**Permit No: 0012240**

**Site Address: 919 8TH AV SAC**

**Nature of Work: 10' MSNRY WALL TRELLIS BBQ GAS ELEC + FRONT ARBOR**

**Subject:** CMU Wall at the Mellon Garden, 919 8<sup>th</sup> Ave, Sac CA

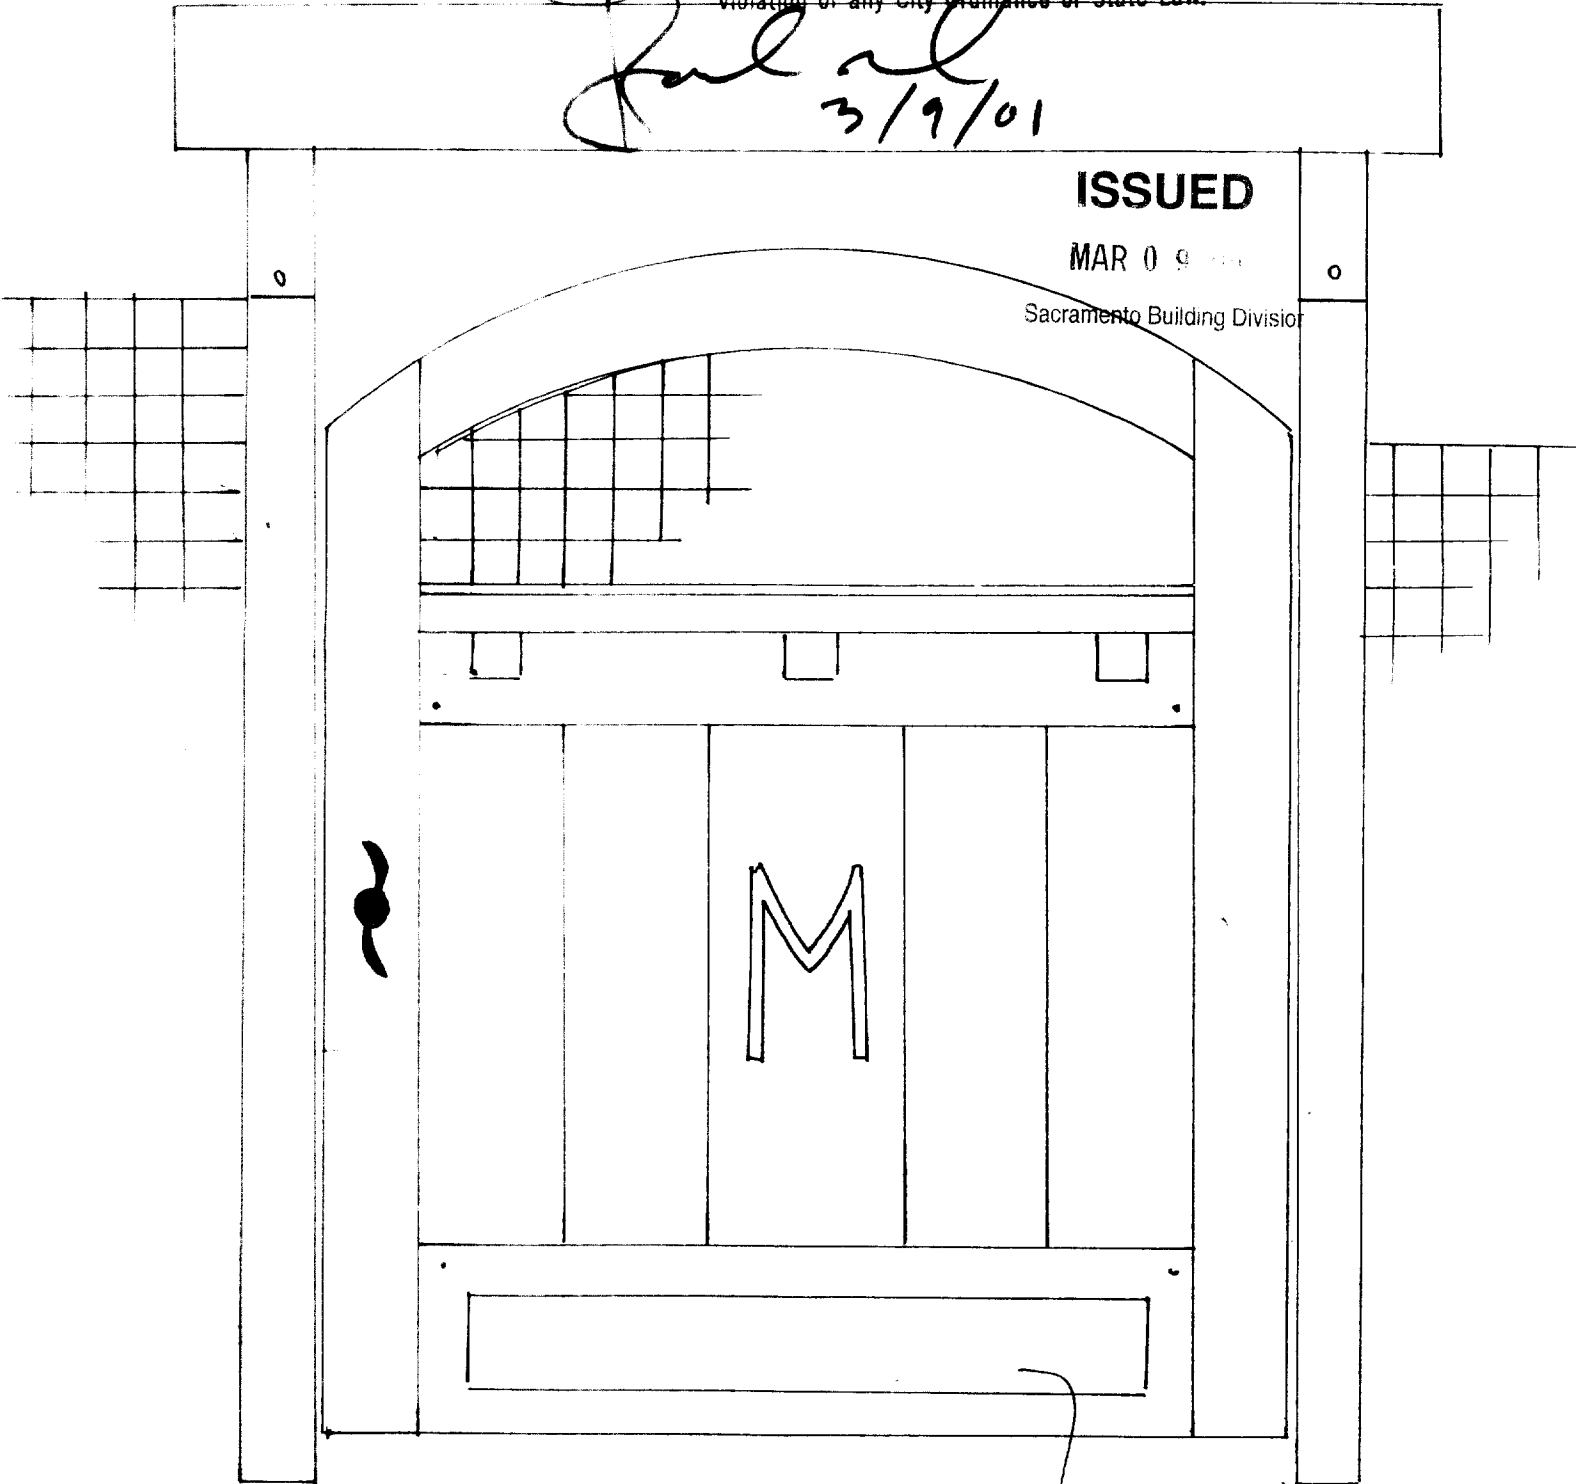
O.K. TO REPLACE AS DESIGN FOR GATE SHOWN ON APPROVED PLANS  
0012240 R  
planter box
